STAFF REPORT

Community Planning and Preservation Commission Certificate of Appropriateness Request

Case No.:	21-90200061
Address:	2763 3 rd Avenue North
Legal Description:	HALL'S CENTRAL AVE NO. 1 BLK 9, W 55FT OF VILLA SITE P
Parcel ID No.:	23-31-16-35082-009-0171
Date of Construction:	1938
Local Landmark:	Kenwood Section – Southwest Central Local Historic District (19-90300002)– Contributing Property

Owners:	Christopher C. Nadeau And Susan K. Dickson
Agent:	Nancy Pacini
Request:	Review of a Certificate of Appropriateness for the replacement of historic windows at 2763 3 rd Ave. N., a contributing resource to a local historic district
Zoning:	Neighborhood Traditional-2 (NT-2)

Figure 1: Window plan shows that every window on the main house will be replaced.

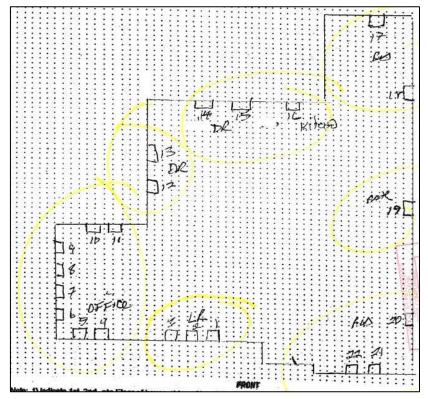
PartiallyThe proposal will not substantially affect the integrity of the Kenwood-consistentSouthwest Central Local Historic District. However, the replacement of original
and historic windows will slightly diminish the subject property's integrity of
materials and workmanship.

The application as submitted includes only single hung windows with no external muntins to replicate the 6-light configuration of the top sash. Staff suggests that approval of this application be conditioned upon installation of contoured, external muntins to replicate the historic windows' configuration.

- 1. Replacement windows will feature contoured, three-dimensional external muntins that replicate the existing configuration.
- 2. Windows will be installed to be setback within the wall plane and feature a reveal of at least two inches, to match existing window reveal.
- 3. Wooden exterior casing and trim will be reinstalled in kind.
- 4. All other necessary permits shall be obtained. Any additional work shall be presented to staff for determination of the necessity of additional COA approval.
- 5. This approval will be valid for 24 months from the date of this hearing, with an expiration date of July 13, 2023.

Window Diegram Sheet

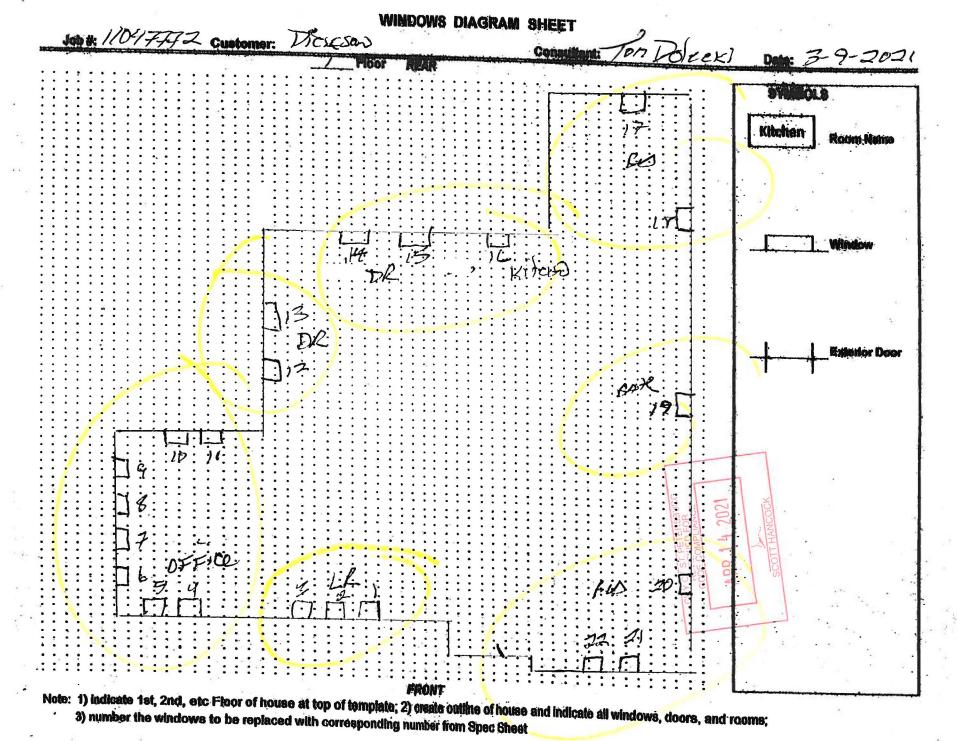
necessary aspect of the district's retained historic integrity. The application does not propose utilizing grids, which will not retain the historic configuration of the windows.

SomewhatThe windows proposed to be installed in the application do not feature grids,Inconsistentwhich will change the design, arrangement, and style of the historic windows.Staff has told the applicant that the installation of external grids to match the
six-over-one configuration will be a recommended condition of approval.

- Inconsistent The application as submitted states that the proposed windows will not have grids. Staff has discussed the window replacement criteria with the applicant, stating that external, three-dimensional grids should be applied to the replacement windows to increase their compatibility with the criteria.
